Proposal to amend the Proposal for Supplement 8 to the 06 series of amendments to Regulation No. 16 (Safety-belts, ISOFIX and i-Size) (ECE/TRANS/WP.29/2016/98)

Figure 2

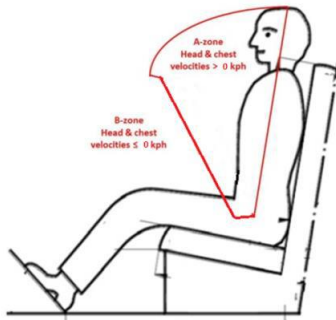
Paragraph 12.1. amend to read:

- “12.1. In case a restraint system has been granted/~~refused~~/~~extended~~/~~withdrawn~~,² those can be used for particular types of vehicles compatible with the following dimensional conditions: no interior part in a quoted A-zone as shown below (Figure 2):

The proposal clarifies the subject of paragraph 12.1 and corrects an editorial error concerning the repetition of footnote 2 that exists already in Annex 1B to Regulation 16.
